S.16 Application No. A/NE-LYT/846

**Proposed Temporary Warehouse (excluding Dangerous Goods Godown) with
Ancillary Office and Associated Filling of Land for a Period of 3 Years in
“Agriculture” Zone, Lot 386 RP in D.D. 85, Fanling, New Territories
(Application for Permission under s.16 of the Town Planning Ordinance)**

Comments from Transport Department

Swept Path Analysis -LGV (Into)

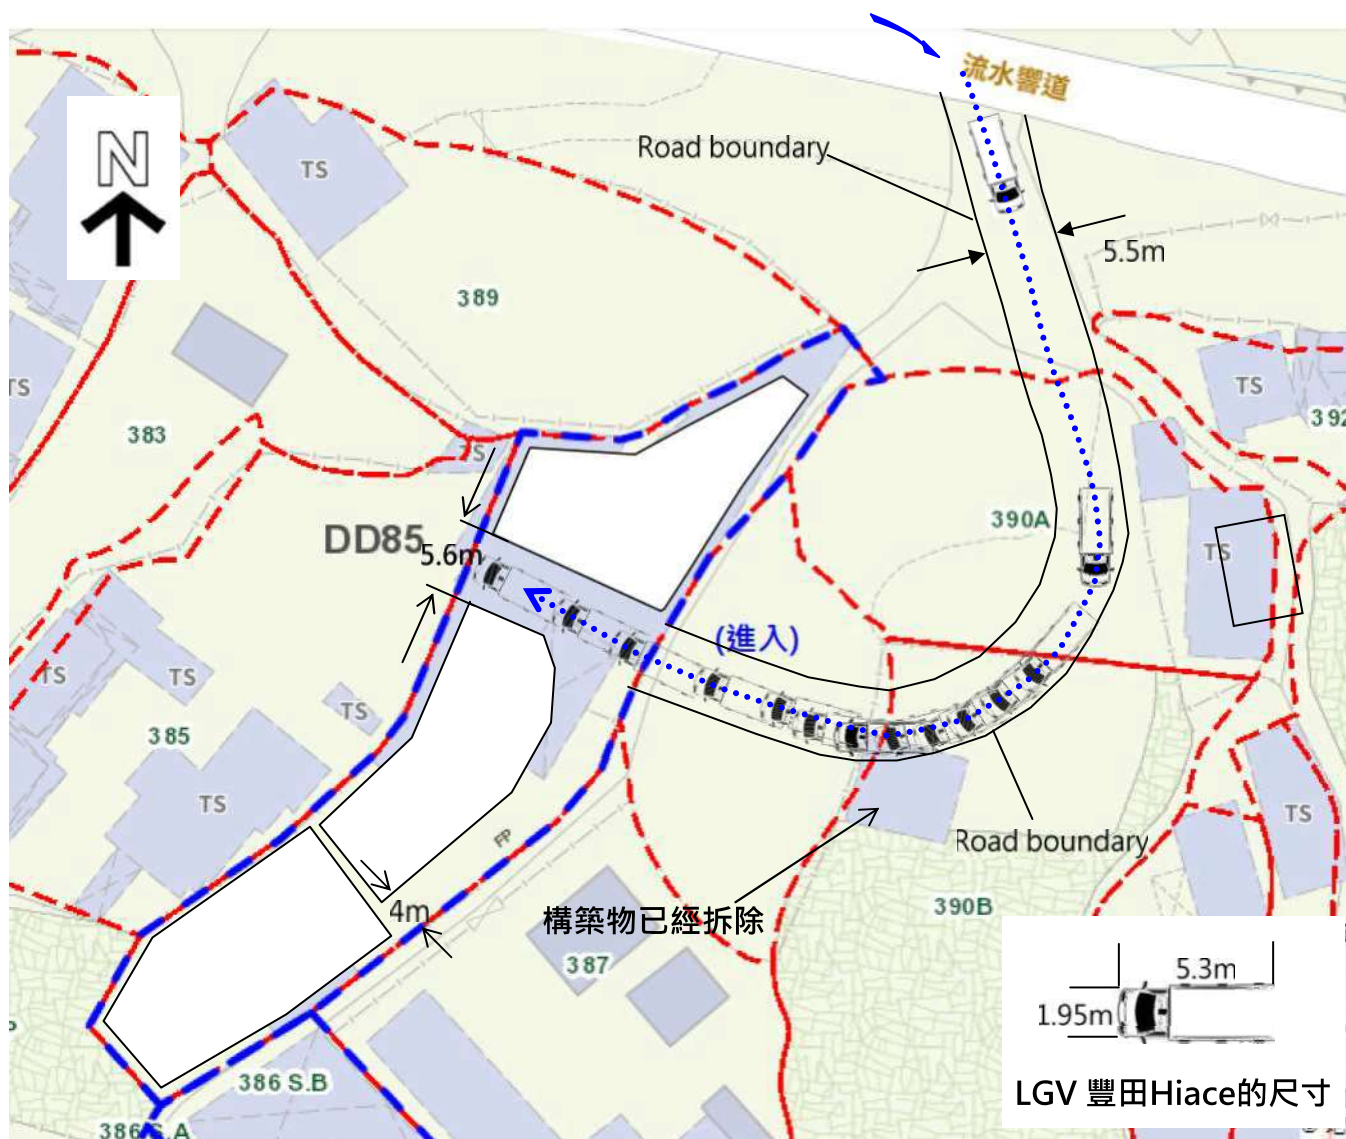
2. The applicant should indicate the boundaries of the road between Lau Shui Heung Road and the vehicular entrance of the subject site in the swept path diagrams.

回覆提問2.

補充有關路段界線及掃描行車路線圖
